Attachment 1

Beaver Valley Power Station, Unit Nos. 1 and 2

Proposed Emergency Preparedness Plan Changes

FIG. 2.1
MAP OF BVPS EMERGENCY
PLANNING ZONE (EPZ)
0-10 MILES

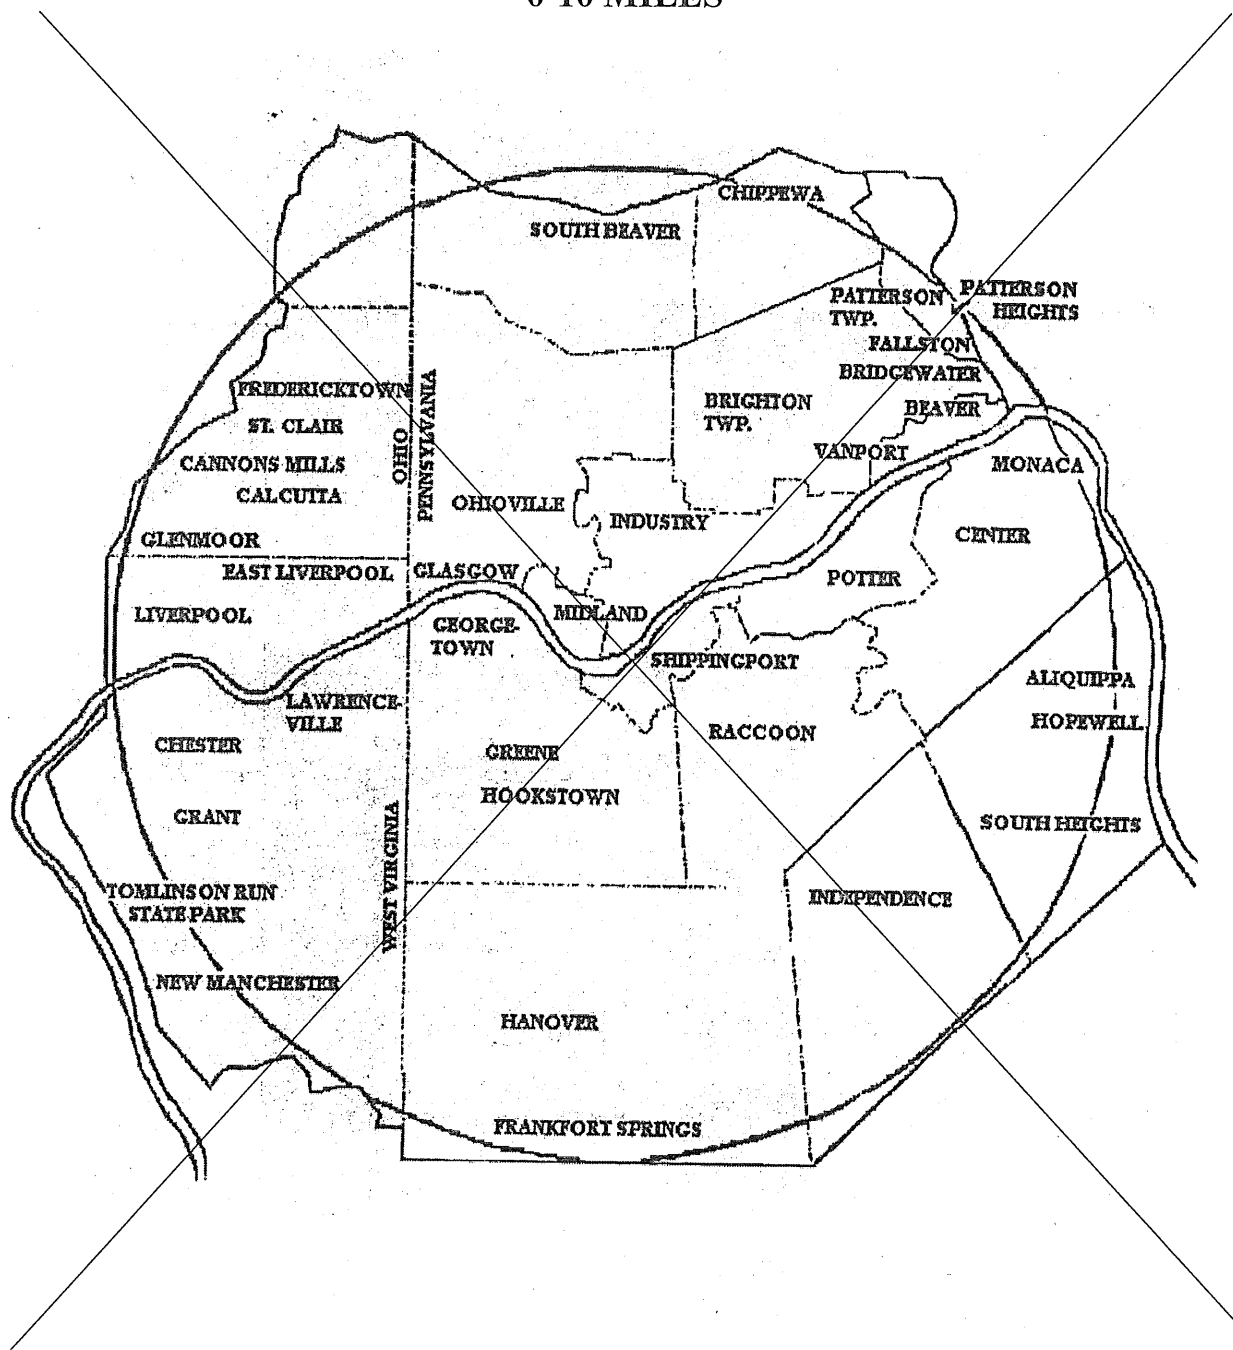
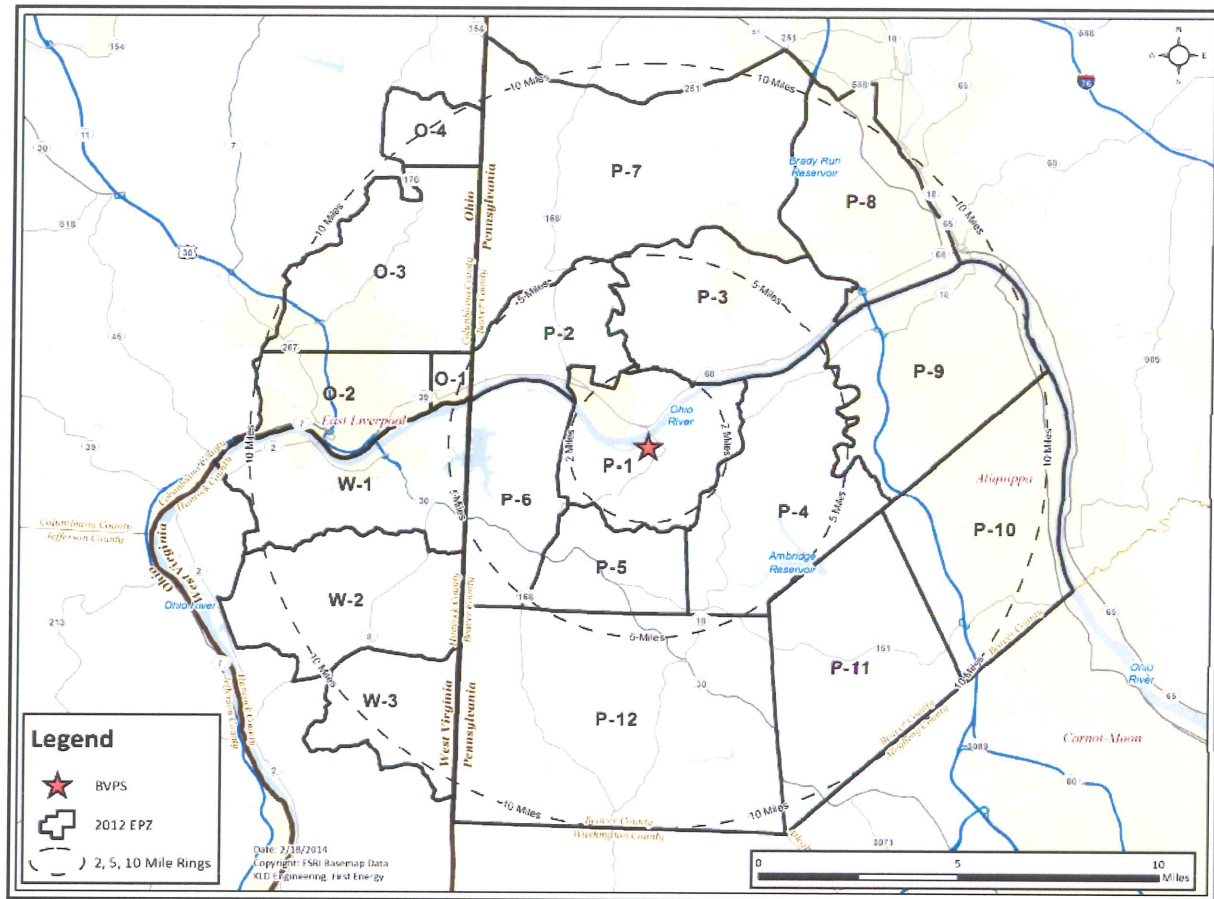
Replace above figure with the following figure

Figure 2.1
BVPS 10-mile Emergency Planning Zone
